**PLANNING AND ZONING COMMISSION AGENDA-REGULAR MEETING**  
Monday, March 12, 2018  
Ketchum City Hall  
480 East Avenue North, Ketchum, ID 83340

**STAFF REPORT**  
**KETCHUM PLANNING AND ZONING COMMISSION**  
**REGULAR MEETING OF MARCH 12<sup>th</sup>, 2018**

**PROJECT:** Stott Residence

**REQUEST:** Mountain Overlay Design Review

# Phase 2 Construction Management Plan

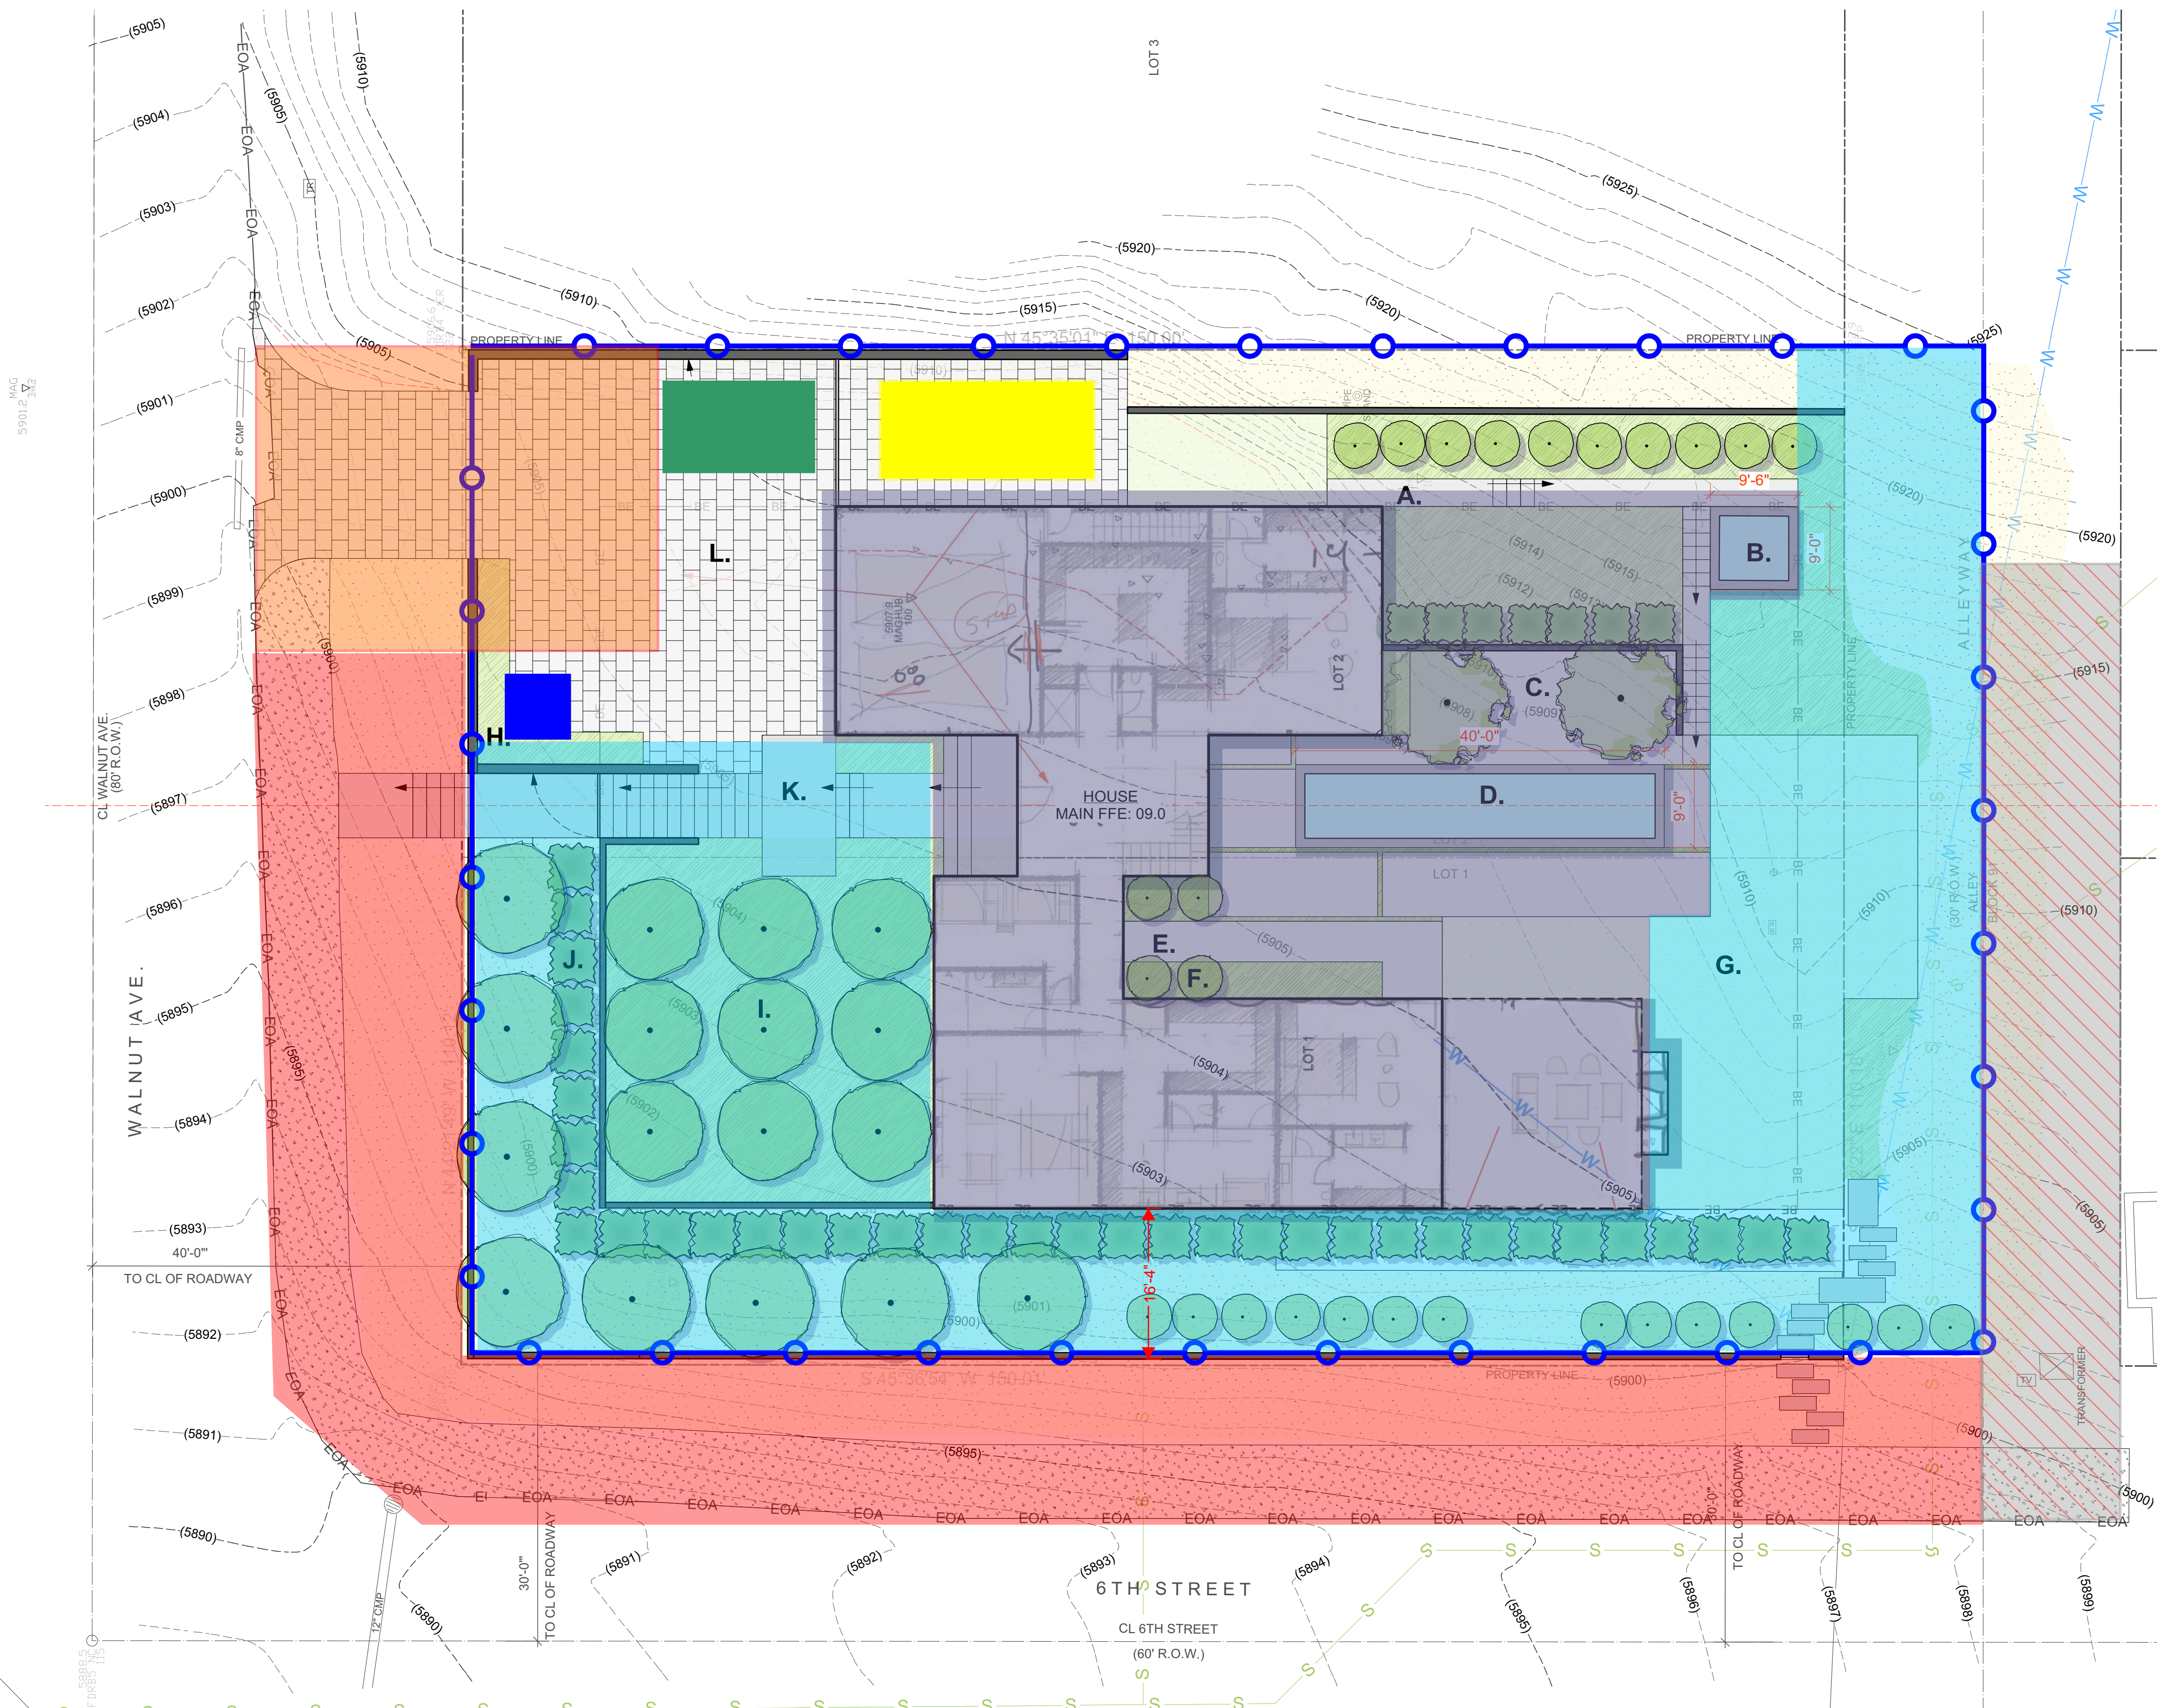
**The alley may not be utilized as a temporary road for equipment access during construction as indicated on the Phase 2 Construction Management Plan.**
